MILITARY SPECIFICATION

TACHOMETER, RATE, COMPUTER: 11732700

This Amendment forms a part of Military Specification MIL-T-48460B (An) dated 30 June 1981, and is approved for use within the U.S. Army Armament, Munitions and Chemical Command and is available for use by all Departments and Agencies of the Department of Defense.

FIGURE 2. Output load for ripple measurement.

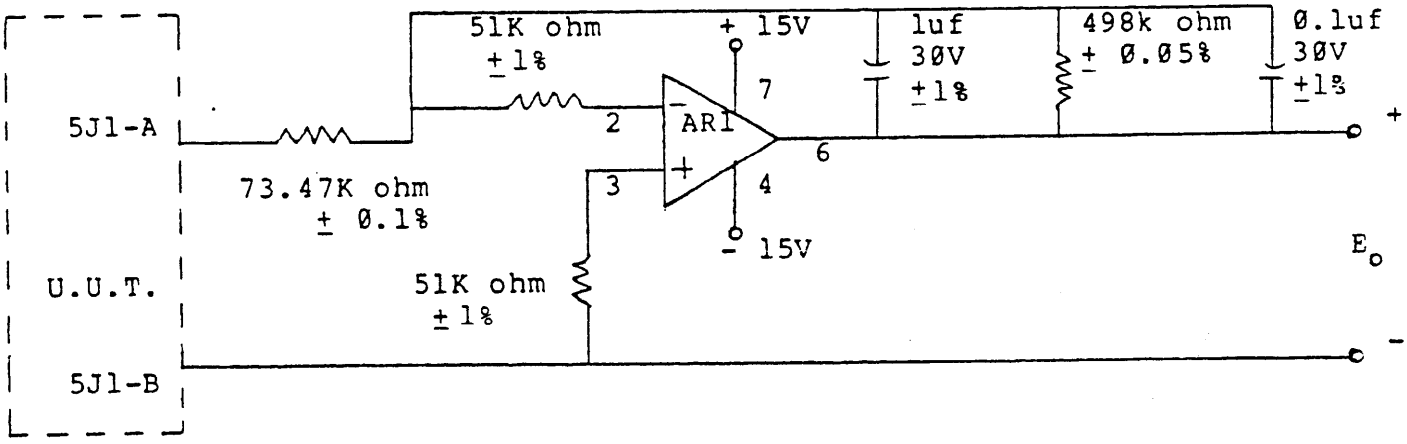
Figure 2, delete in its entirety and substitute:

NOTES: Resisters per MIL-R-55182
Capacitors per MIL-C-83421
AR1 is LM107H\883

FIGURE 3. Positive shaft rotation.

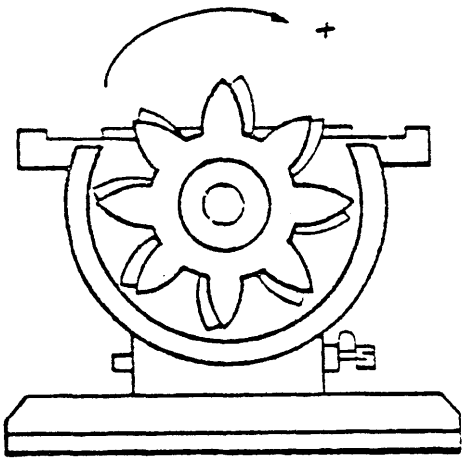
Figure 3, Delete in its entirety and substitute:
